1990 Corvette: Service Bulletin: ABS Code 63 Revised Diagnostic Chart

Subject: SERVICE MANUAL UPDATE SEC. 5E1 ABS DIAGNOSIS-
REVISED CODE 63

Bulletin Number: 90-430-5 - (08/21/1991)

CODE 63
 (PAGE 1 OF 3)
SOLENOID VALVE RELAY
 (RELAY FAULT)

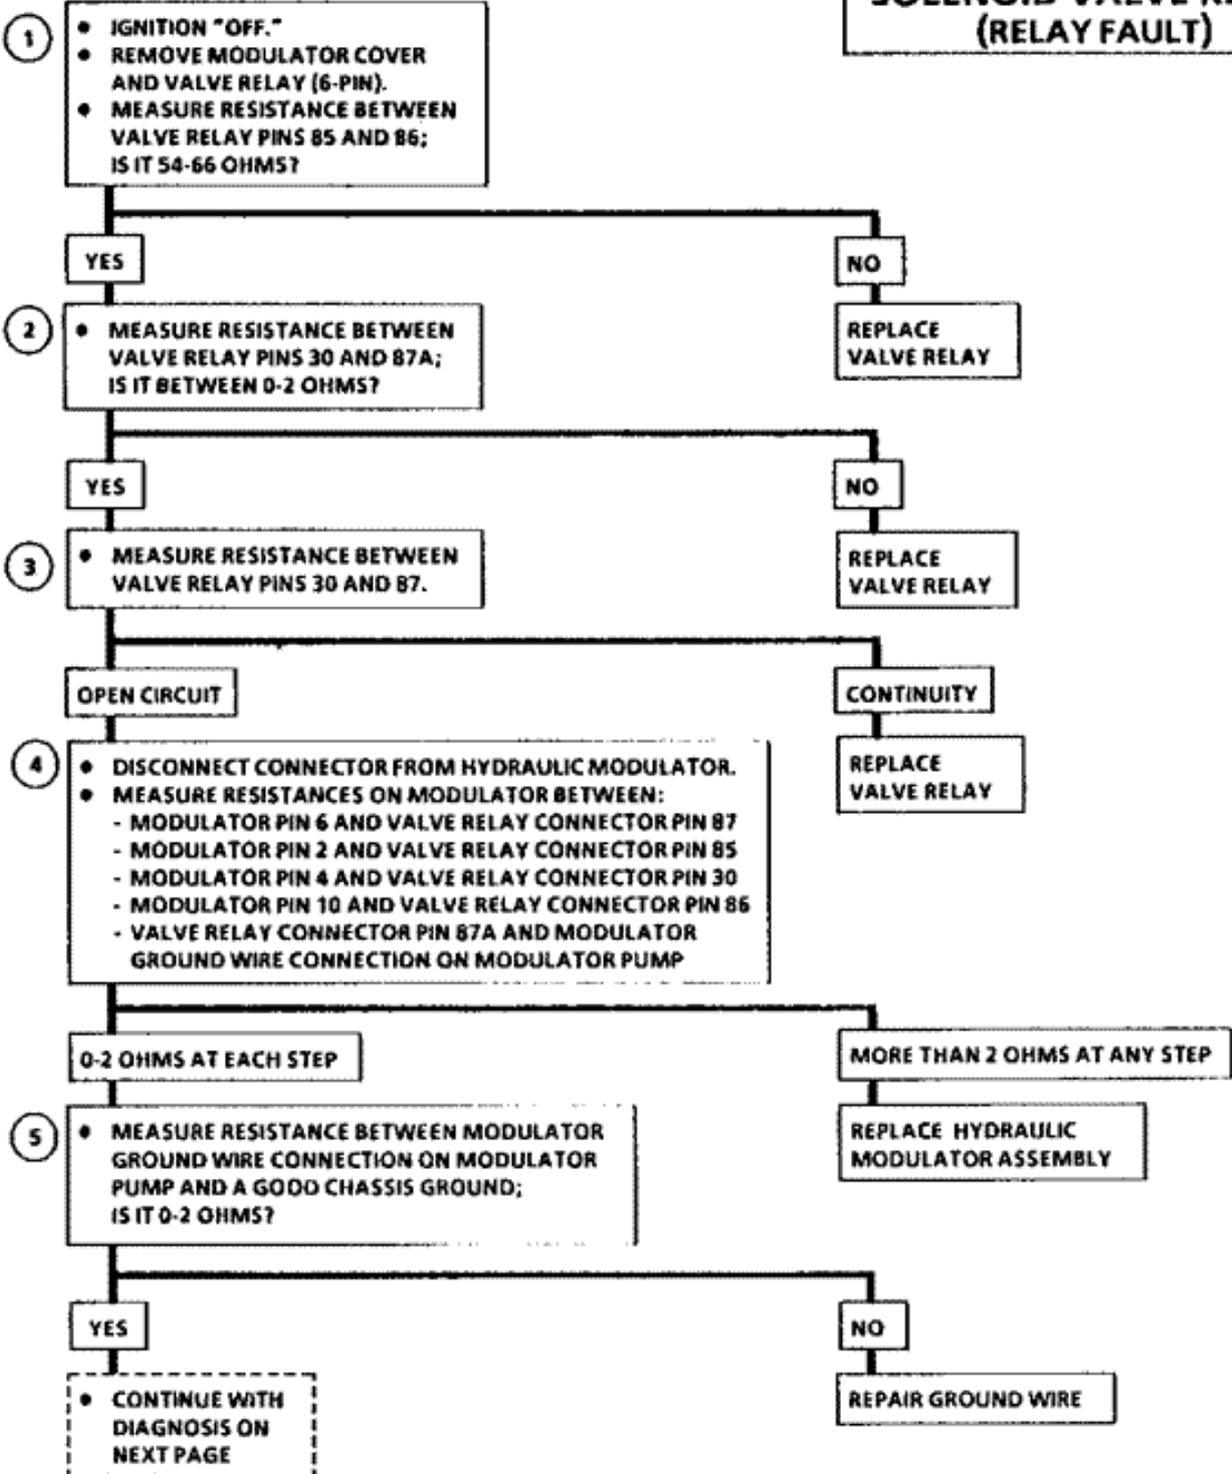
This bulletin serves to update the ABS Code 63 (Page 1 of 3) diagnostic chart on page 5E1-37 in Section 5E1 "Antilock Brake System Diagnosis" of the 1990 "Y" Service Manual. Please use the attached revised Code 63 (Page 1 of 3) diagnostic chart when diagnosing ABS Code 63 conditions on 1990 Corvettes.
